Access Compliance Report

Public Rights-of-Way

(Curb Ramps)

Intersection ID: 13709	Main Street: SHENANDOAH_AV	Cross Street: ST_JULIEN_ST	Location: E
ADA ID: FF612D2199AC	Ramp Type: PerpDiag	Initial Pass/Fail: Fail	Overall Compliance: No
Severity Score: 21.25			
Codes/Mitigation Info/Possible Solution		Field Measurements/Component Compliance

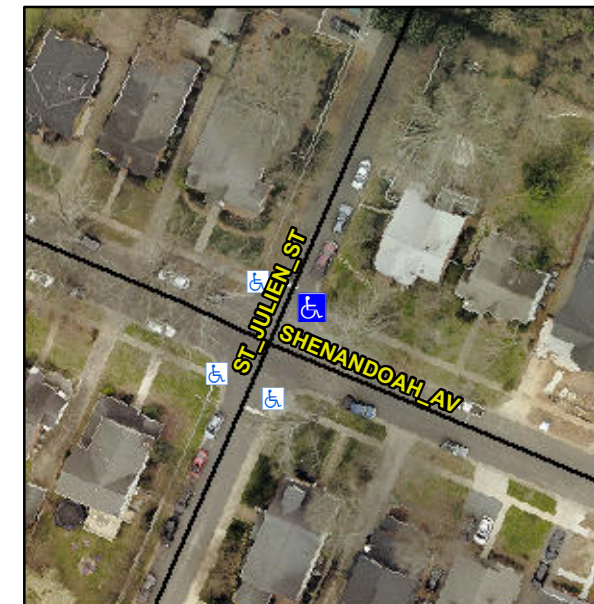
Not Found, R304.5.1, R304.2.2

Compliance	Description	Data	Compliance	Description	Data
N/A	Ramp Length (in)	56.0	No	Ramp Slope (%)	9.3
No	Ramp Width (in)	40.0	Yes	Ramp XSlope (%)	1.9
N/A	Flare Type LT	N/A	N/A	Flare Type RT	N/A
N/A	Flare Slope LT (%)	N/A	N/A	Flare Slope RT (%)	N/A
N/A	Flare Traversable LT?	N/A	N/A	Flare Traversable RT?	N/A
N/A	Landing Length (in)	N/A	N/A	DWS Provided?	N/A
N/A	Landing Width (in)	N/A	N/A	DWS Contrast?	N/A
N/A	Landing Slope (%)	N/A	N/A	DWS Length (in)	N/A
N/A	Landing X Slope (%)	N/A	N/A	DWS Full Width?	N/A
N/A	Landing Curb? (Y/N)	N/A	N/A	DWS Offset (in)	N/A
N/A	Shared Landing?	N/A			
N/A	Gutter Ponding?	N/A	N/A	Gutter Slope (%)	N/A
N/A	Gutter Lip Ht (in)	2.0	N/A	Gutter X Slope (%)	N/A
N/A	Painted X Walk1?	No	N/A	Painted X Walk2?	No
	X Walk 1 Direction	To NW		X Walk 2 Direction	To SW
N/A	X Walk 1 Width (in)	N/A	N/A	X Walk 2 Width (in)	N/A
	X Walk 1 Slope (%)	1.8		X Walk 2 Slope (%)	1.4
	X Walk 1 X Slope (%)	1.0		X Walk 2 X Slope (%)	0.1

Remove & Replace Curb Ramp With Two New Directional Ramps or Equivalent.
